REQUEST FOR PROPOSAL

Addendum # 3

RFP Title: **On-Board Systems / Communication Center System**

RFP Number: **04-001PR**

Wireless Access Points (WAP) Coverages for ATLANTIC/CENTRAL BASES

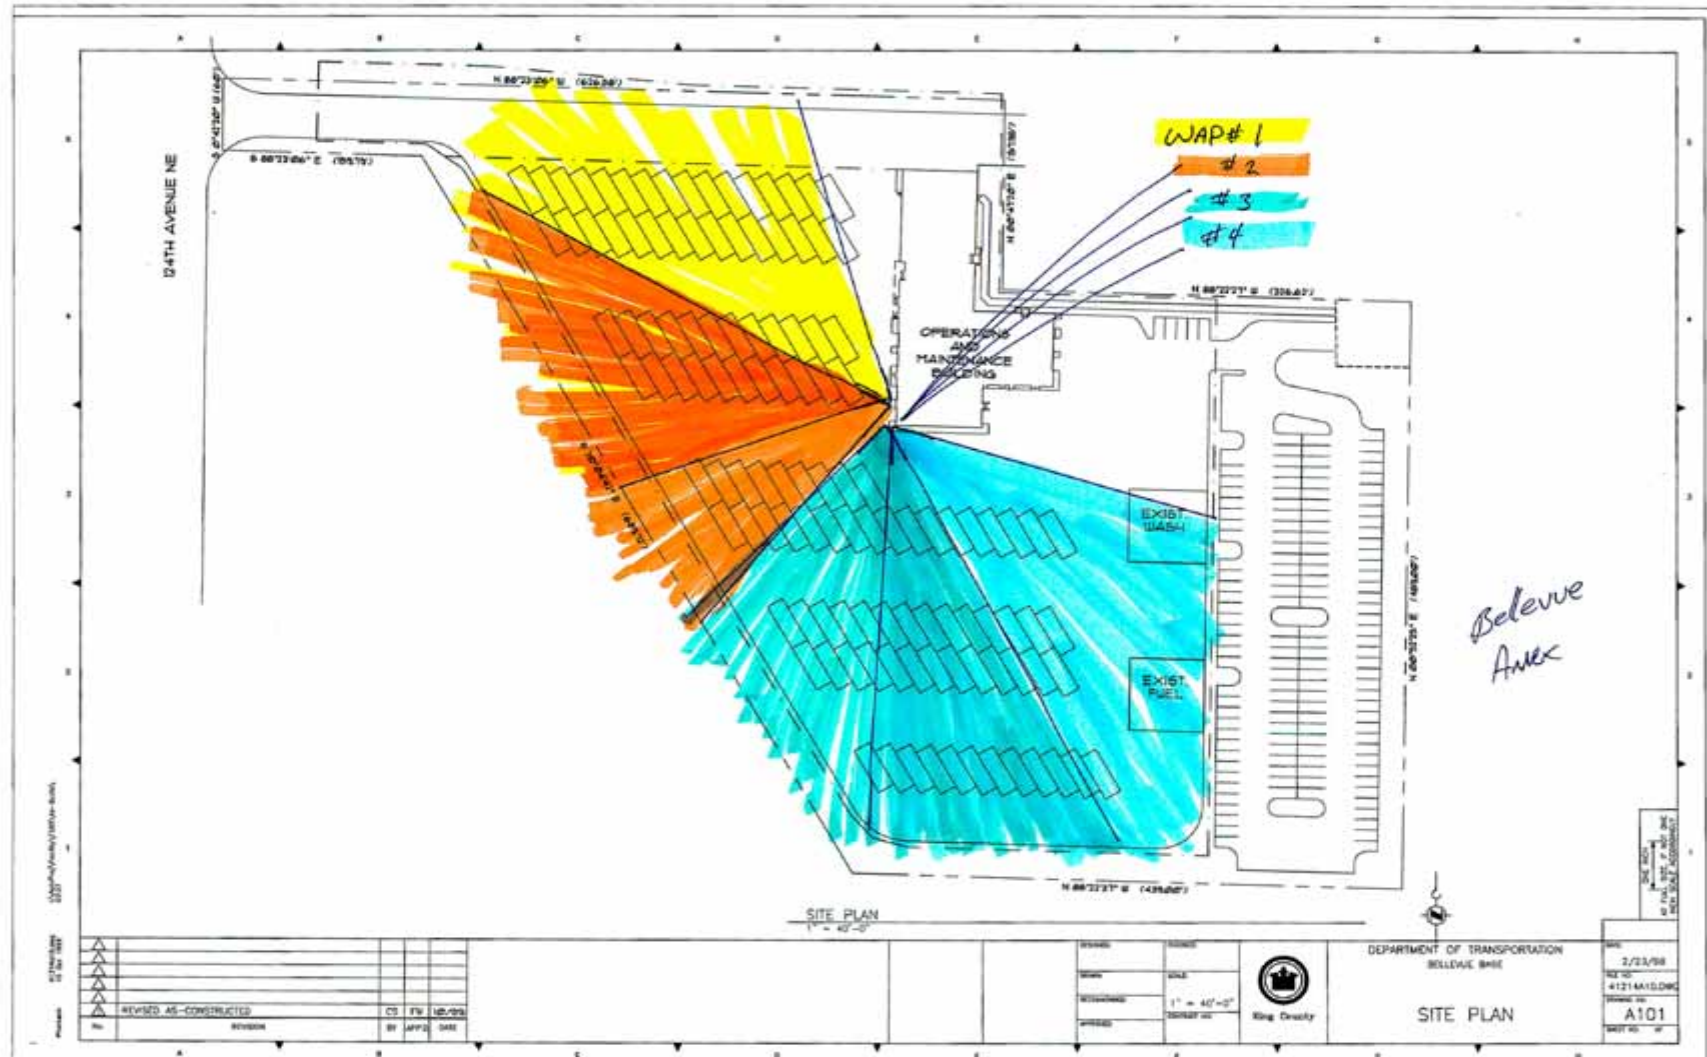
33.	New appendix	Where are the access points for the 802.11b?	<p>ADD: Appendix N, WAP Coverages at Transit Bases, shown below in Attachment Five.</p>
